SSD-9138102: 290-308 Aldington Road, 59-62 Abbots Road and 63 Abbots Road, Kemps Creek

Ethos Urban write on behalf of ESR Australia, the proponent for a State Significant Development Application 9138102 (SSDA) at 290-308 Aldington Road, 59-62 Abbots Road and 63 Abbots Road, Kemps Creek. The SSD is seeking consent for development of a warehouse and distribution facility, in response to Secretary's Environmental Assessment Requirements (SEARs) received on 17 December 2020.

Table 1 Responses to DPE commentary

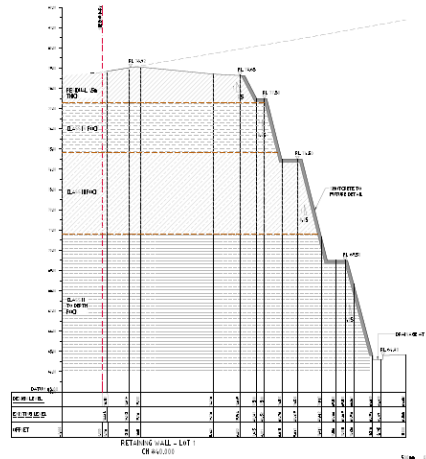
Update the canopy cover calculations if it is found that some proposed planting is not viable in relation to matters raised above. The MRP DCP stipulates public roads should not be included in canopy coverage.

The canopy cover across Stage 1 development has been updated. Lot 1 has reduced by 1%. Canopy cover however still meets the 10% requirement for each lot.

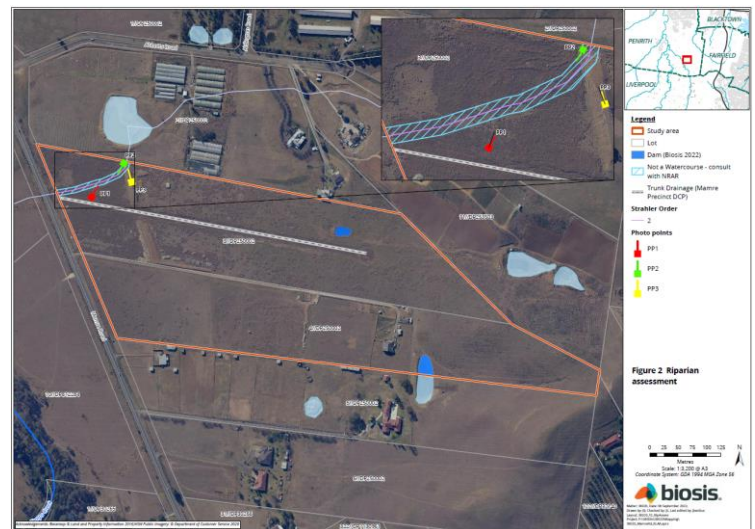
Ensure updated rendering and illustration of the proposed retaining wall accurately depict the proposed landscaping are consistent with the engineering plans show proposed materials that are viable in terms of cost and engineering and include a street level viewpoint.

Landscaping and civil engineering have been coordinated. ESR has worked with a structural engineer to ensure the retaining wall can be designed to support landscape features within its setback. Further, the materials and types of retaining walls are consistent across the two technical streams. ESR has costed all retaining walls across the site with the structural engineer and can confirm these can be delivered as per the Civil and Landscape plans.
